South Carolina Department of Health
and Environmental Control

June 29, 1988

In regard to the report "Review of the Structural Design of Polyethylene High Integrity Containers" by S.A. Silling, the Department has several comments and questions.

REVIEW OF THE STRUCTURAL
DESIGNS OF POLYETHYLENE
HIGH INTEGRITY CONTAINERS

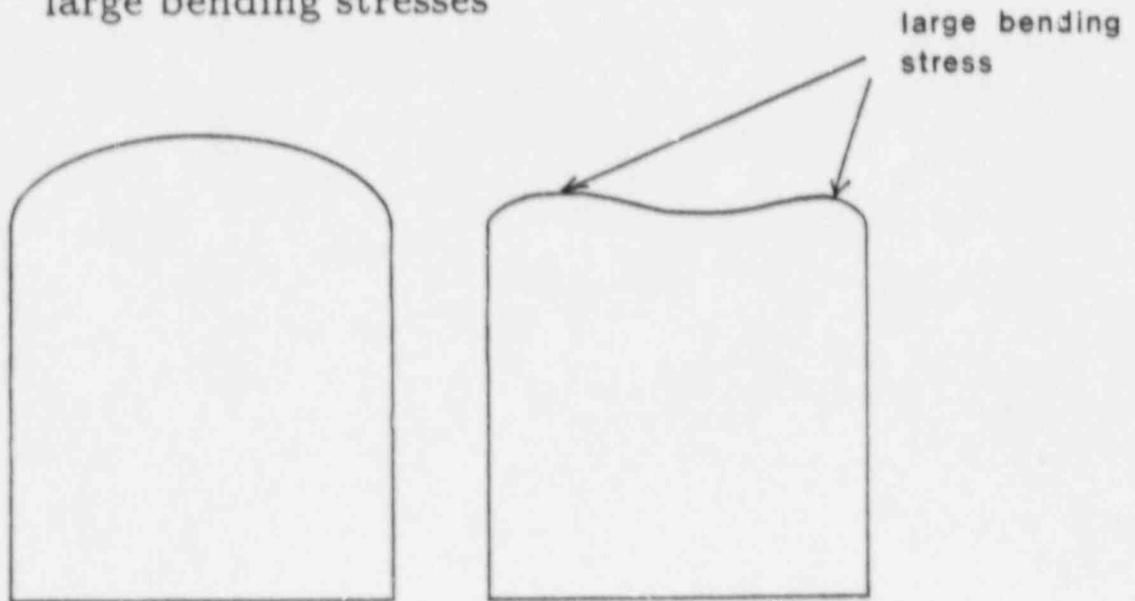
- 1) Please verify the use of secant modulus instead of Young's Modulus. Secant modulus is usually used for metals.
- 2) Assumption's that are based purely on tensile data cannot be considered adequate. Although there is little data on HDPE, most of the loads experienced by the containers are compressive.
